SUPPLEMENTAL ENVIRONMENTAL IMPACT STATEMENT for the Alpine Satellite Development Plan for the Proposed Greater Mooses Tooth One Development Project

Volume 3: Chapter 8 Public Comments and BLM Responses

October 2014

Figure 2: CD5 Pipeline Design Height

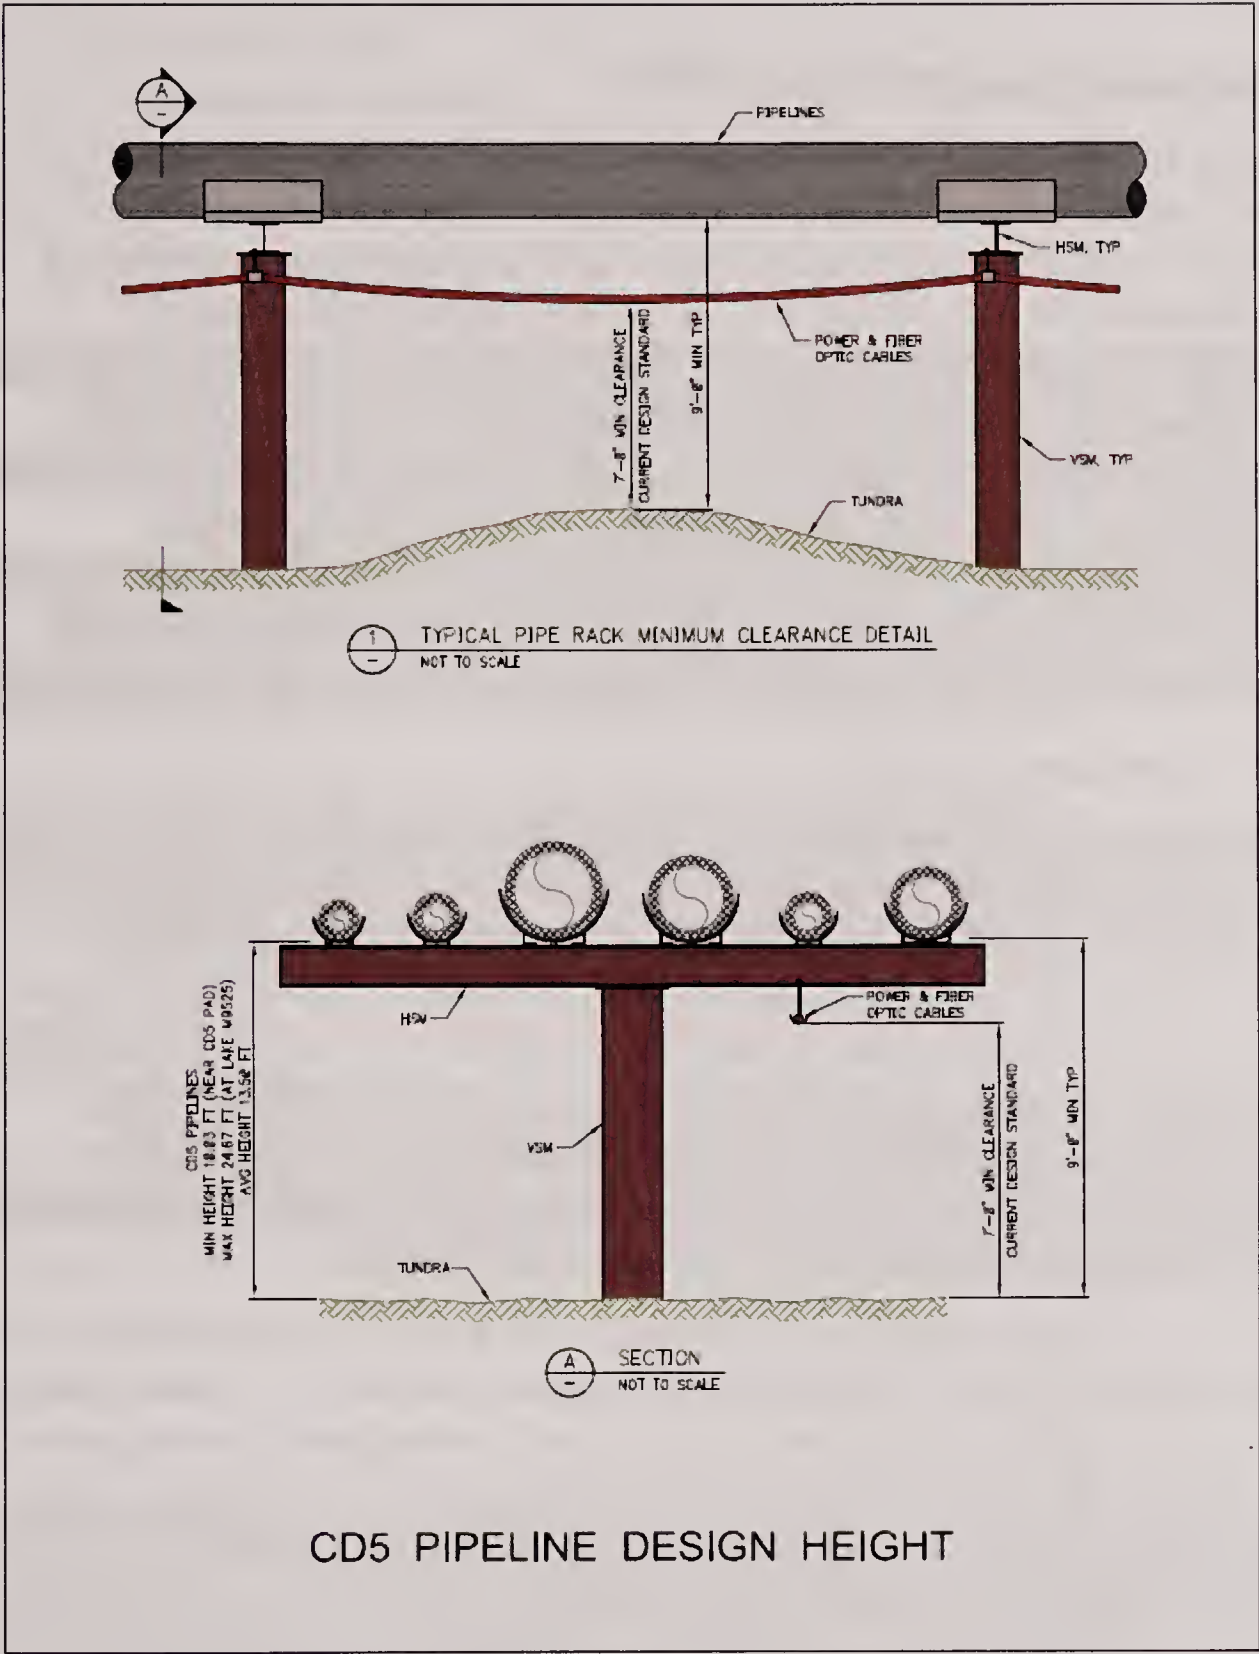
[18-128] Pipelines and roads are designed to allow free movement of caribou and the safe, unimpeded passage of the public while participating in subsistence activities. Above-ground pipelines are elevated a minimum of 7 ft as measured from the ground to the messenger cable installed on the pipeline VSMs. In most instances, this relates to a minimum distance of 9 ft from the ground to the bottom of the pipeline (Figure 1). Depending on the terrain and the hydraulic design, this actual height can be much greater. For example, the height from the ground to the bottom of the pipeline for the CD5 pipeline ranges from 10 – 24 feet (at Lake M9525) (Figure 2). A minimum distance of 500 ft between pipelines and roads will be maintained, where feasible, as studies have shown that this facilitates caribou movement.
